**ON-SITE SEWAGE DISPOSAL SYSTEM
HOWARD COUNTY HEALTH DEPARTMENT
BUREAU OF ENVIRONMENTAL HEALTH**

04-361288

SUBDIVISION: Stirn Farm LOT NUMBER: 242

ADDRESS: 697 West Watersville Road PROPERTY OWNER: Esslinger

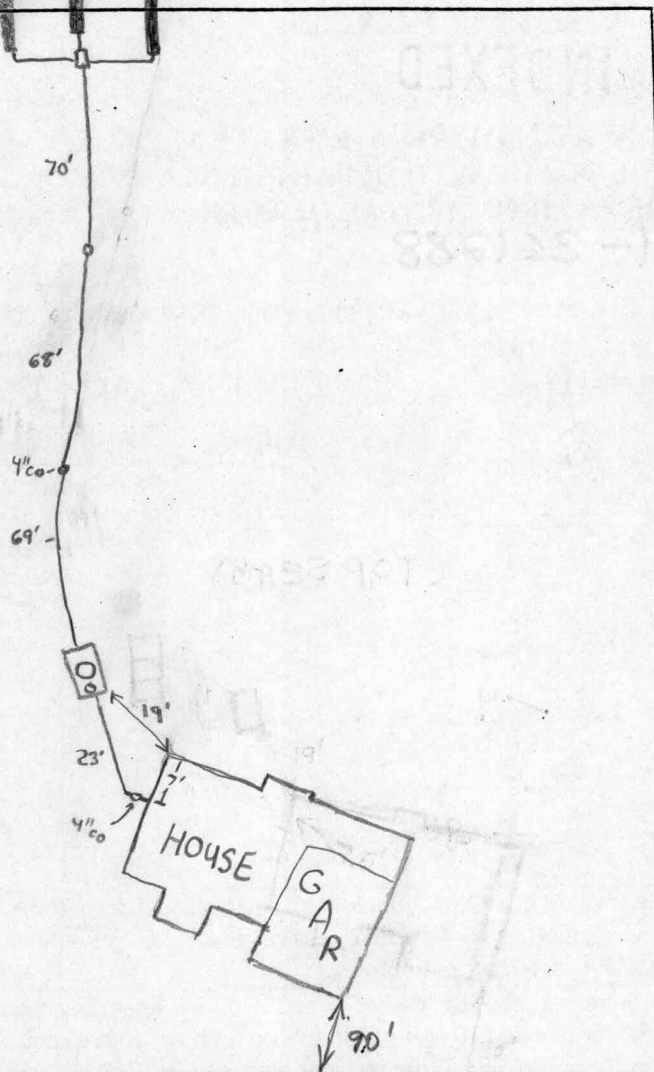
PRE-CONSTRUCTION INSPECTION: 10/26/01 Contour not as shown on B.P. plan.

To install 3-93' trenches across top of easement. (BB)
